CITY OF WOODBURN
COMMUNITY DEVELOPMENT

MEMORANDUM

Date: June 8, 2020
To: Dago Garcia, P.E., City Engineer
Cc: Chris Kerr, AICP, Community Development Director
Roy Hankins, PE, Emerio Design
From: Colin Cortes, AICP, CNU-A, Senior Planner *cc*
Subject: **Planning Division review comments on original / 1st submittal of civil engineering plans for Smith Creek Development Phase 3B**

EXHIBIT P

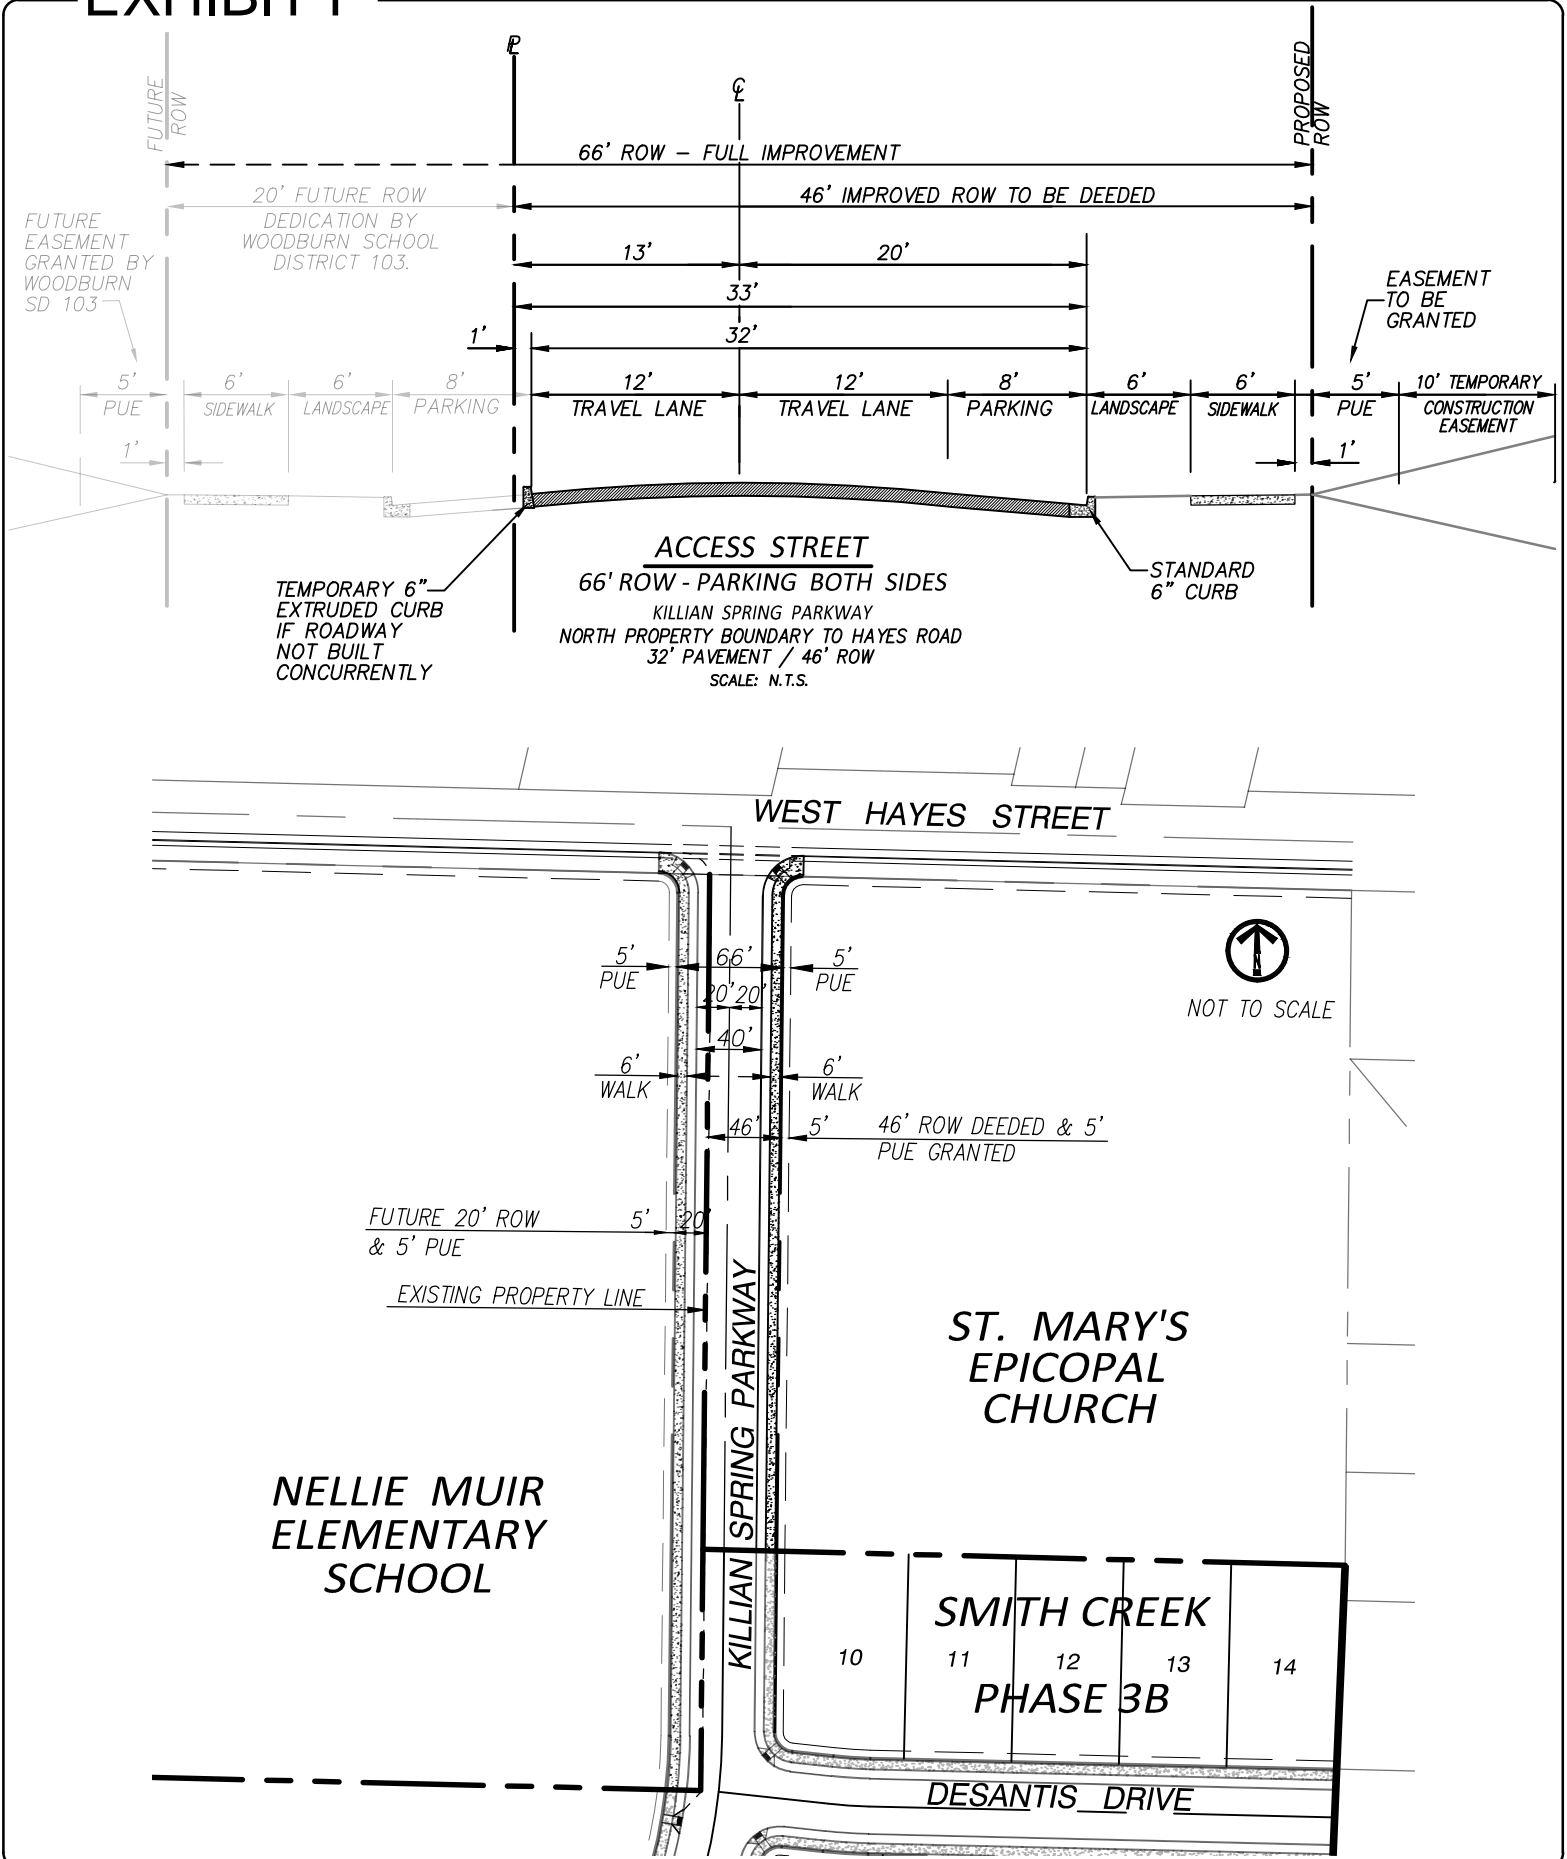
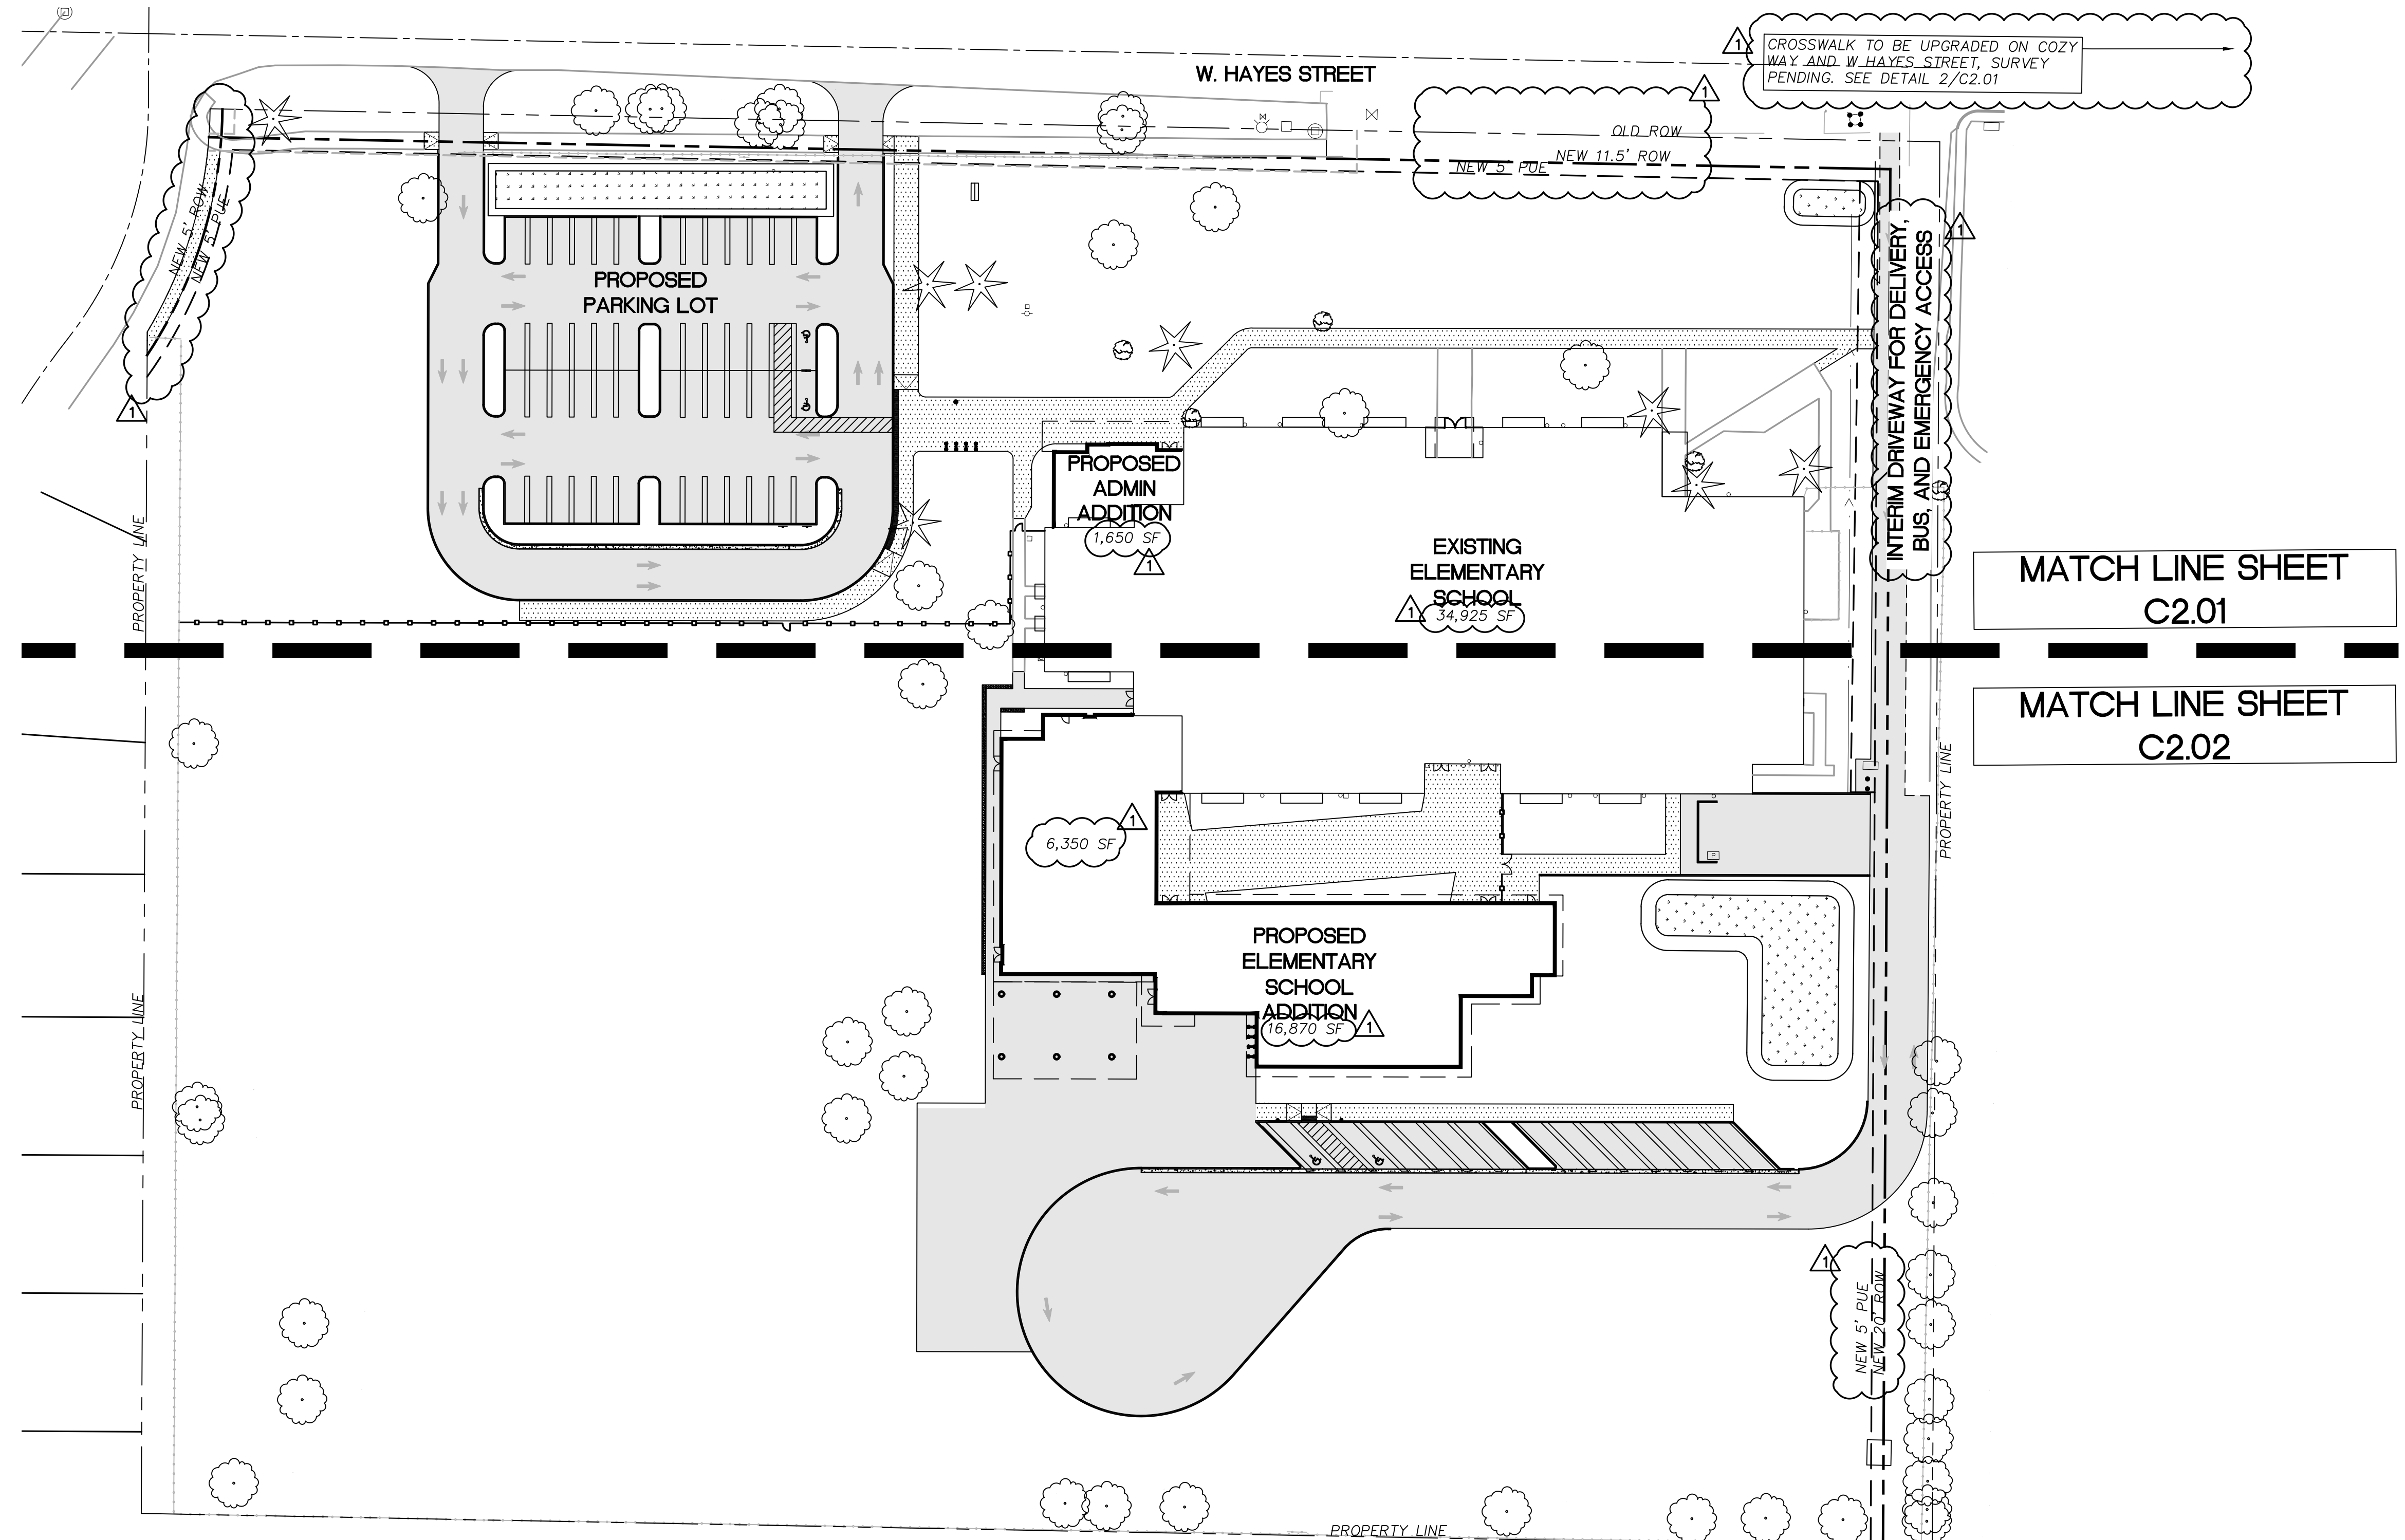
I recall that in the last two to three years Morgan Will of Stafford mentioned that St. Mary's Episcopal Church (1560 W. Hayes St; Tax Lot 051W07CC07100) had granted an easement on its property for its 46-ft wide portion of Killian Spring Drive. Additionally, Smith Creek Development [Exhibit P](#) (2018; Attachment 2) labeled "46' ROW deeded & 5' PUE granted".

I understand that the Woodburn School District dedicated ROW to the City for the school portion of Killian Spring Drive: 20 ft wide plus curvature at the intersection with W. Hayes Street per the [Exhibit P](#), as well as a public utility easement (PUE), as a result of Conditional Use [CU 2019-05](#) final decision Condition C1a.
